Product Change Description

Model Name: T6831

FCC ID: 2AH25T6831

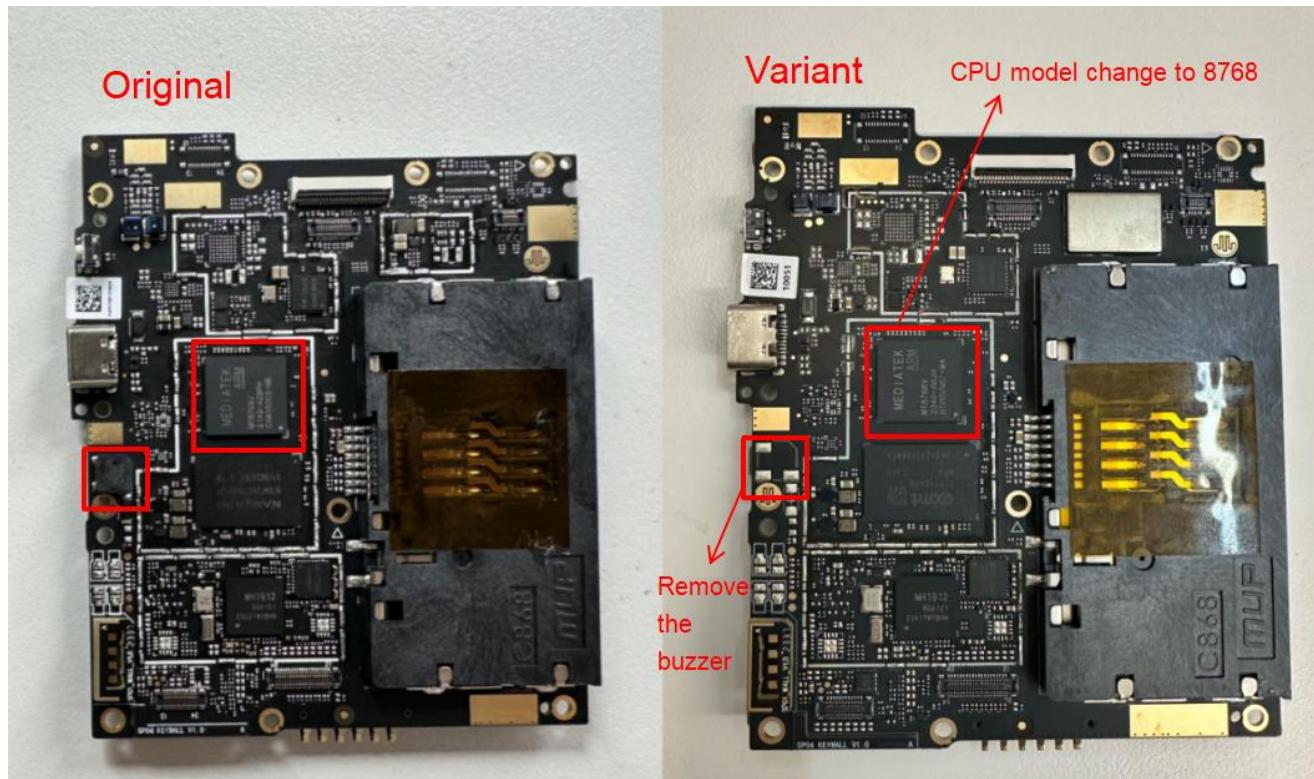
Camera changes: Please refer to the following difference chart

Type of Service	Model Name	Front camera	Pogo Pin	CPU
Original	T6831	YES	YES	8766
Variant1	T6831	YES	YES	8768

Variant2	T6831	NO	NO	8768
----------	-------	----	----	------

The CPU chip model is changed from 8766 to 8768, and the two CPU chips are PIN to PIN, and the RF performance will not be affected.

The difference between the Original and the Variant of PCBA is shown in the following figure:
